South Texas Project
Units 3 and 4
Docket Nos. 52-012 and 52-013
Supplemental Response to Request for Additional Information

RAI 03.07.01-27, Supplement 3**QUESTION:****Follow-up Question to RAI 03.07.01-19 (STP-NRC-100093)**

RAI 03.08.04-30 Supplement 2**QUESTION:****Follow-up to Question 03.08.04-23**

**Figure 3H.6-209a: Amplified E-W Site-Specific Response Spectra for
Reactor Service Water (RSW) Piping Tunnel
(Based on SSI Analysis of Reactor Building)**

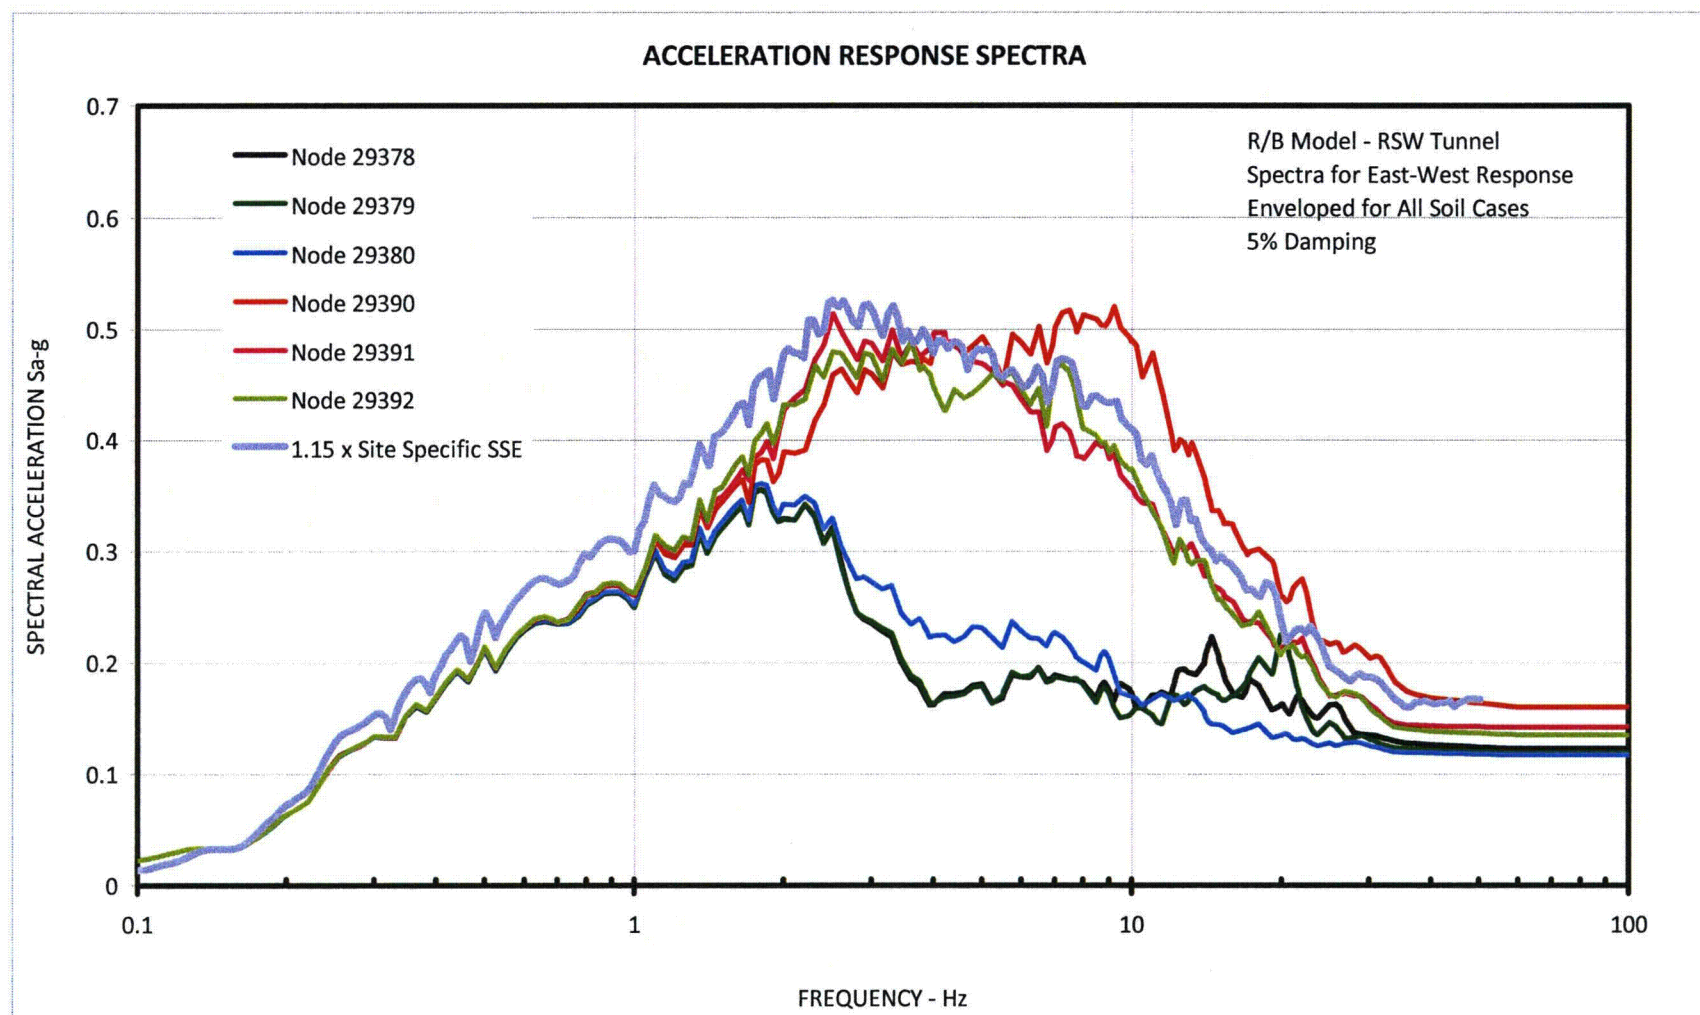
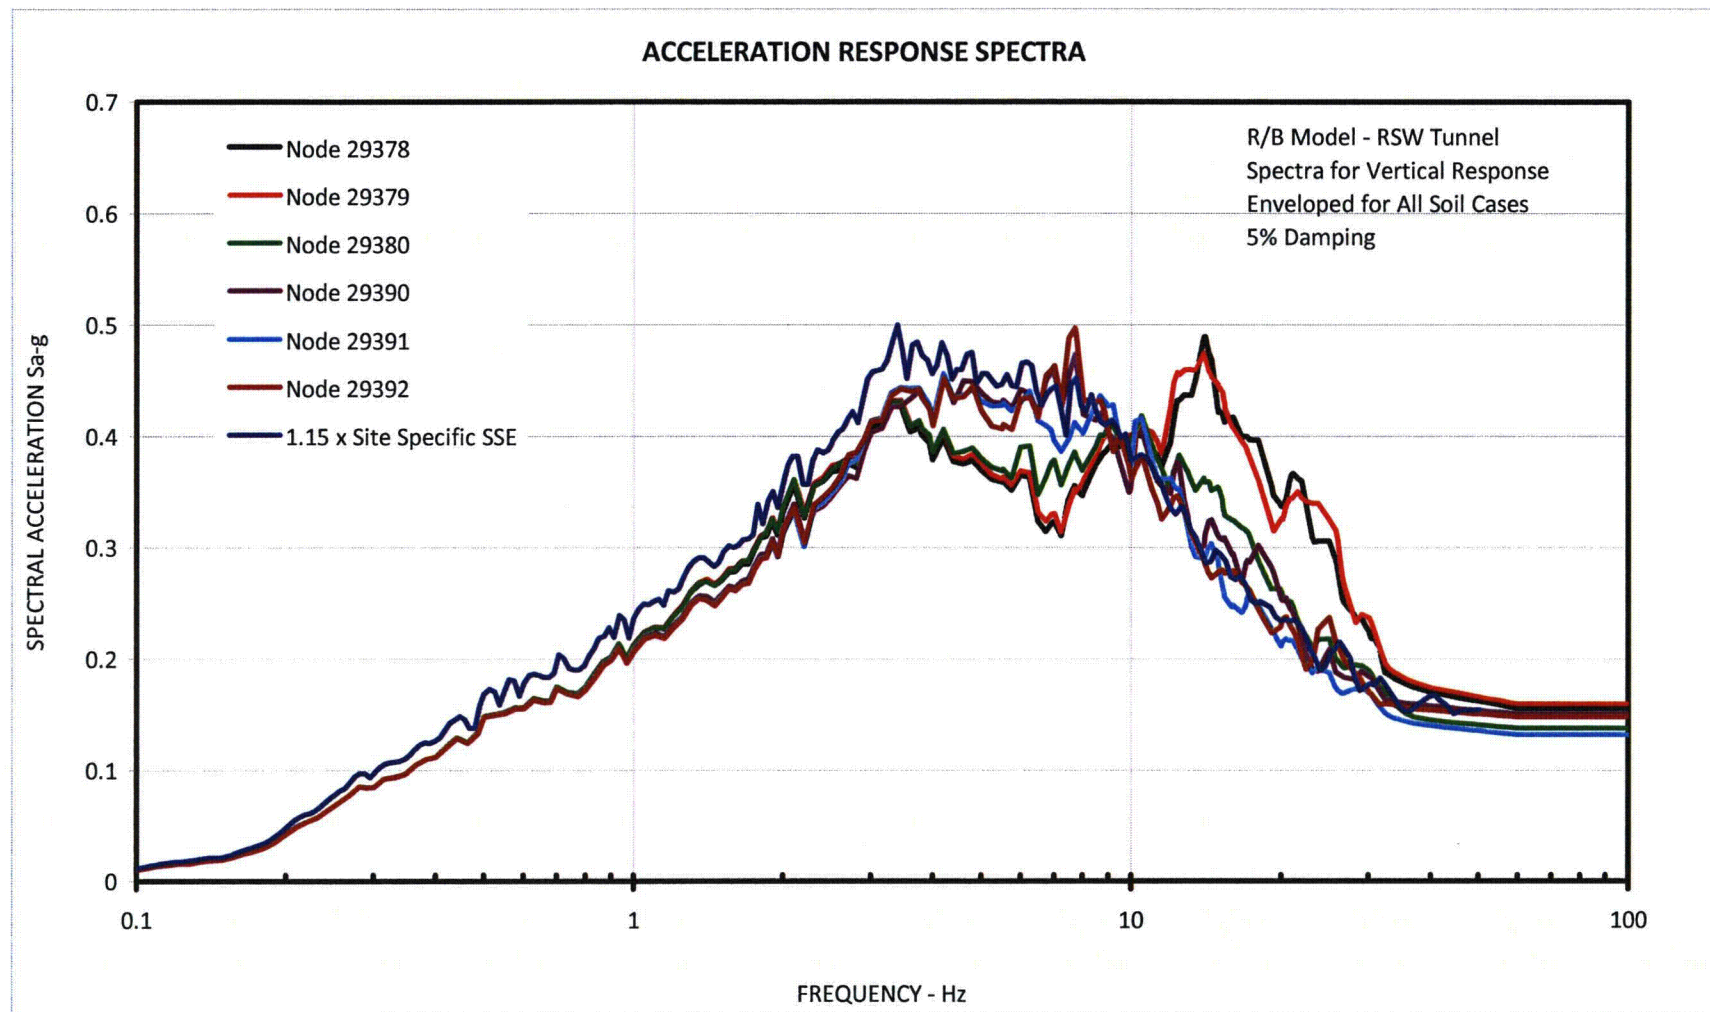
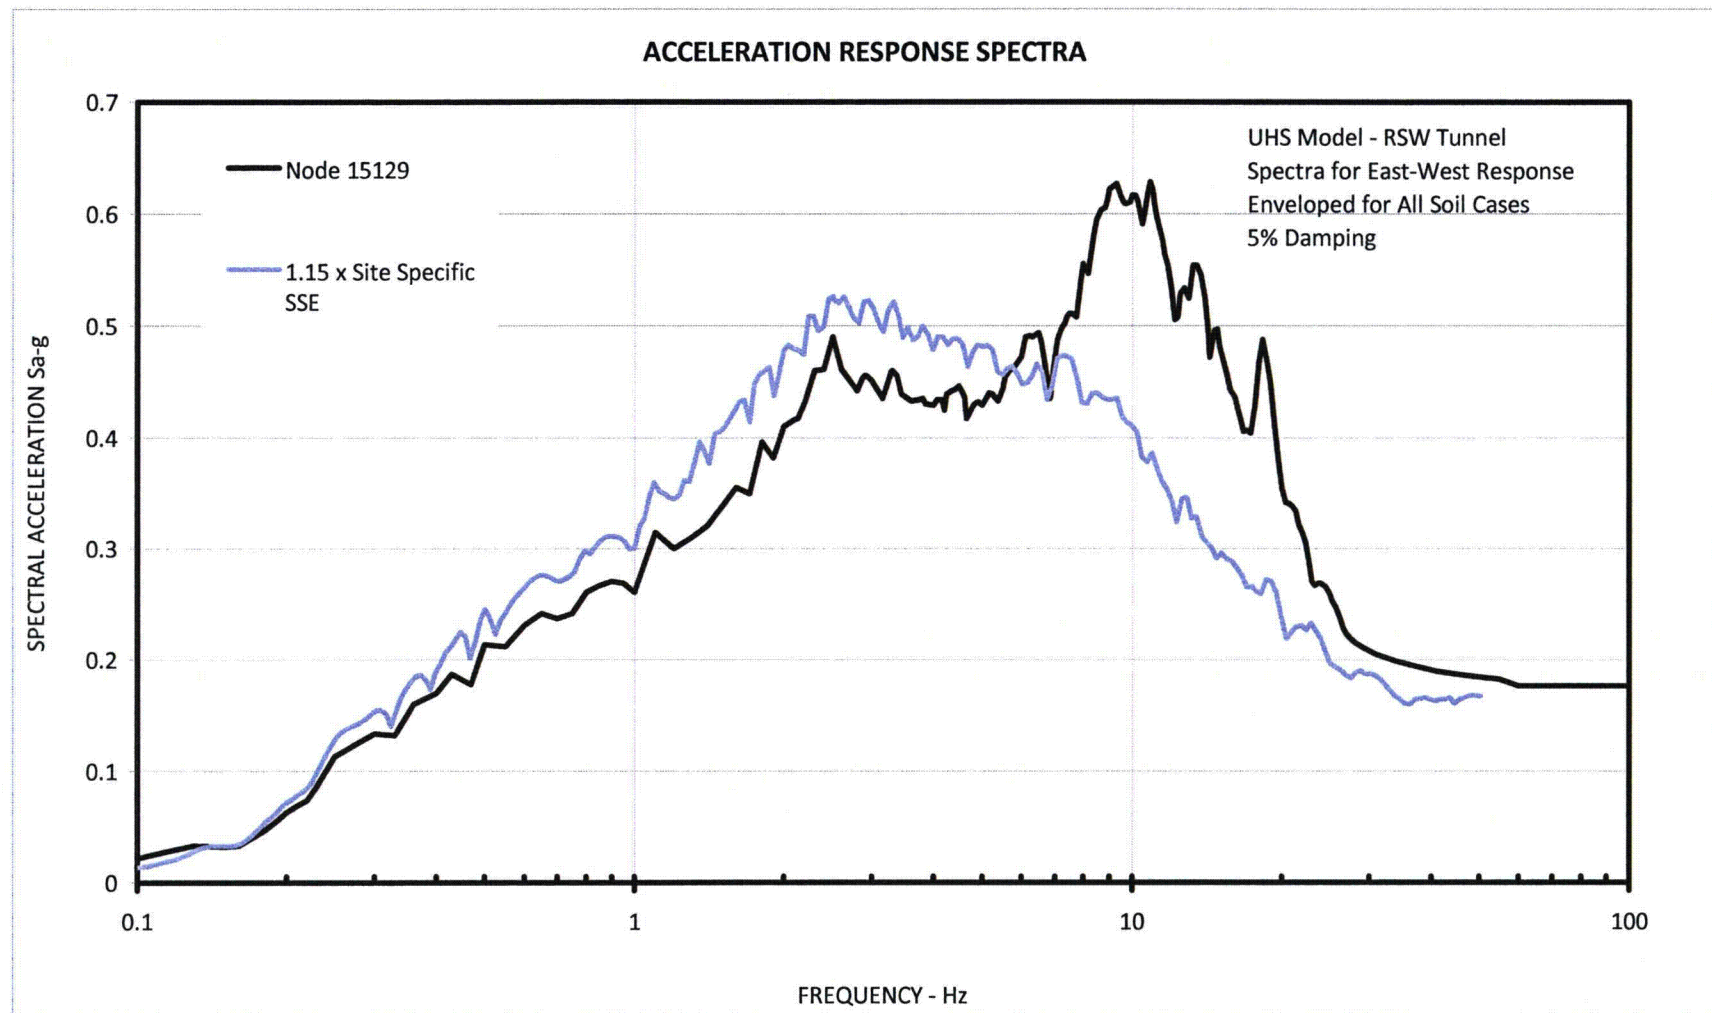
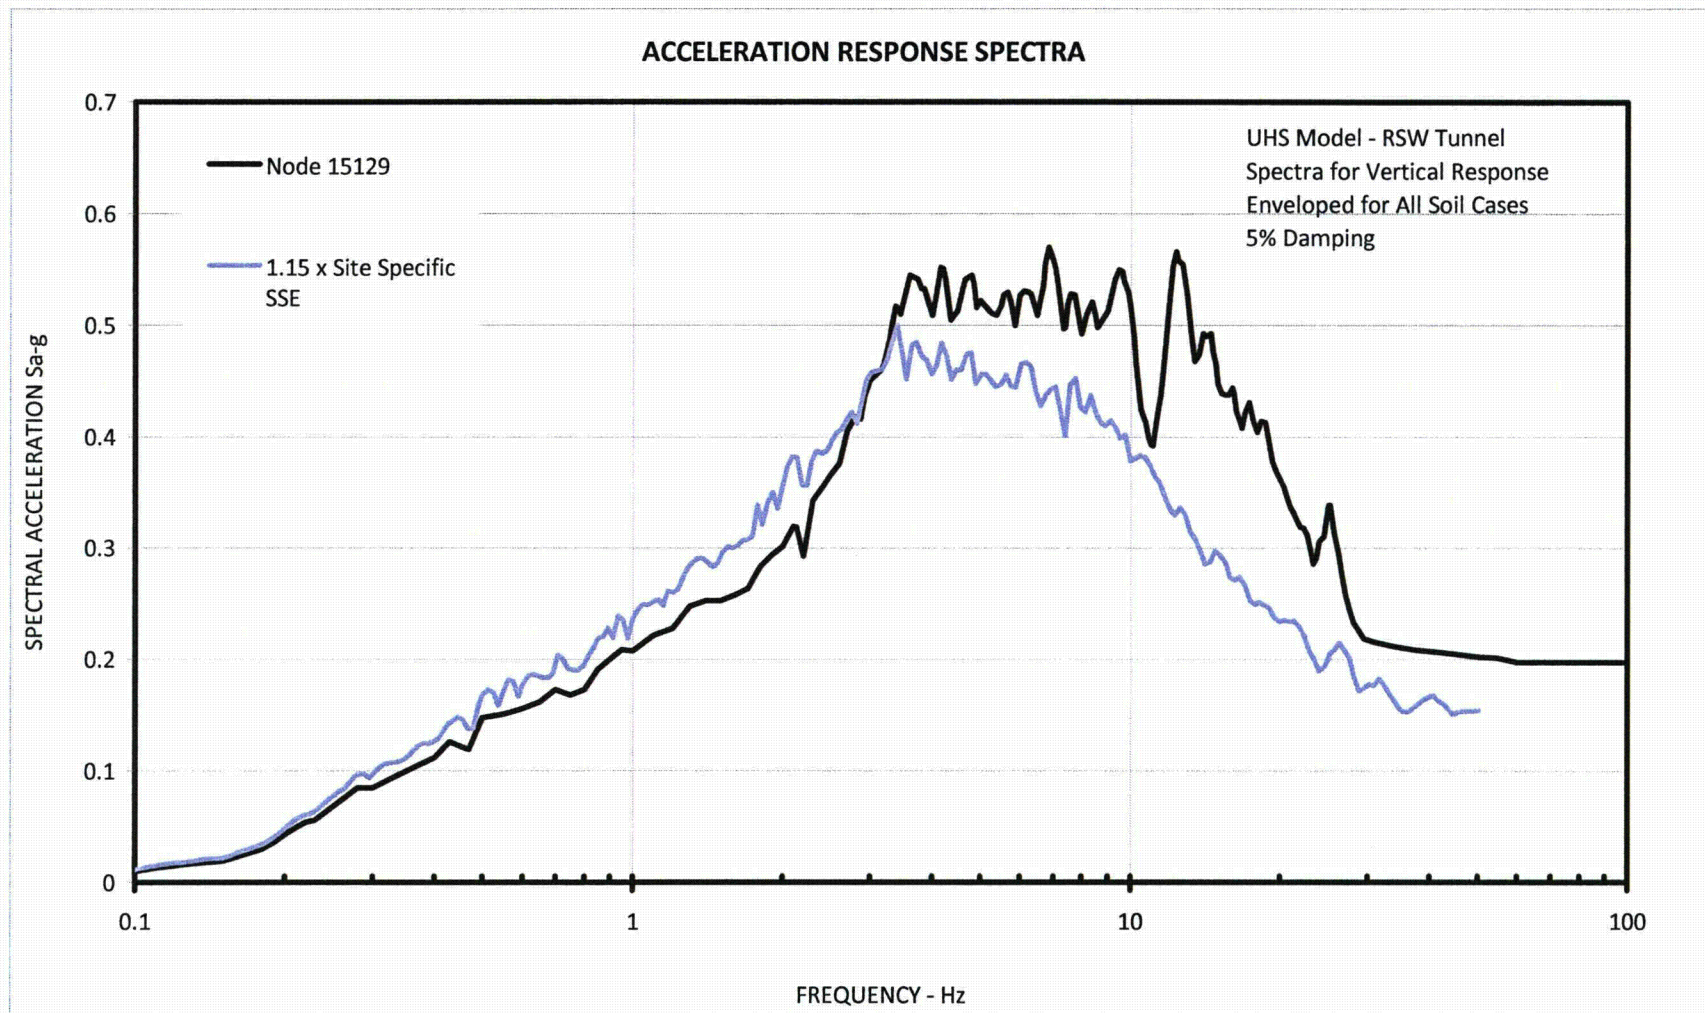
NINA was requested to review the COLA description of how the input motion for the SSI analysis of the Reactor Service Water (RSW) Piping Tunnel, Diesel Generator Fuel Oil Storage Vault (DGFOSV), and Diesel Generator Fuel Oil Tunnels (DGFOTs) was determined, and clarify as necessary (Audit Action Items 3.7-3, 4, and 5). See the discussion provided in the following paragraphs.

- The resulting amplified response spectra at the interaction nodes, representing the response of the RSW Piping Tunnel, from the above SSI analyses of RB and UHS/RSW Pump House were obtained. In order to find a reasonable envelop of these response spectra, to be used in the SSI analysis of the RSW Piping Tunnels, these spectra were compared to 1.15x site-specific SSE to identify those exceeding 1.15x site-specific SSE. New COLA Figures 3H.6-209a through 3H.6-209d includes the response spectra which exceed 1.15x site-specific SSE.

- Based on the comparison of the response spectra shown in Figures 3H.6-209a through 3H.6-209d, six motions were selected as envelop amplified motions for SSI analysis. These six motions correspond to 1.15x site-specific SSE and amplified motion time histories for Nodes 29378, 29379, 29390, 29392, and 15129.

See discussion for the RSW Piping Tunnel in Item A above. New COLA Figures 3H.6-209a through 3H.6-209d show the amplified motion response spectra which were used in the SSI analysis of the RSW Piping Tunnel, as explained in Item A above.
